6_1 4-PAVEMENT LAYER TEMPLATE AND MISSING PGL POINT

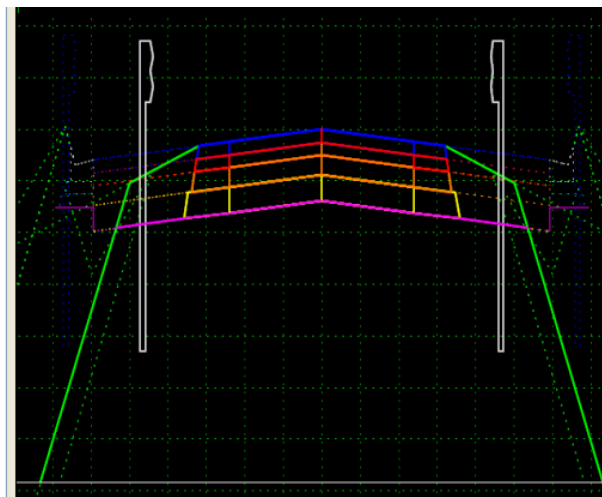
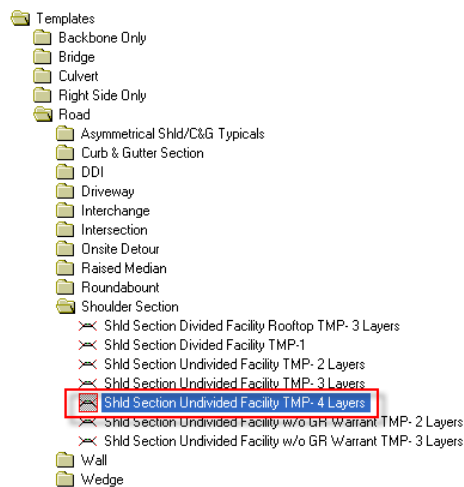
I have a bridge project and we will be showing a 4 layer typical. Will NCDOT be providing a 4 layer undivided facility shoulder template? Also for some reason the PV1_PGL point is not available except when certain conditions are met. I have used the same template in the past without issue. Would you be able to take a look at this and adjust it if necessary?

Thank you for contacting RDU CADD Support. These are the types of feedbacks we are looking for. A four pavement layer template for your project has been created in our standard template library (ITL).

The missing PGL point was due to the new method used by the pavement components to seek the inside existing EOP graphics when they cross over the centerline. See Q&A link below. Basically the PGL point was part of the inside proposed pavement component and is displayed only when the IEEOP graphics are found. Conversely it is turned off when no IEEOP graphic exists. This issue has been fixed in the new 4-layer template. The rest of templates will be fixed shortly.
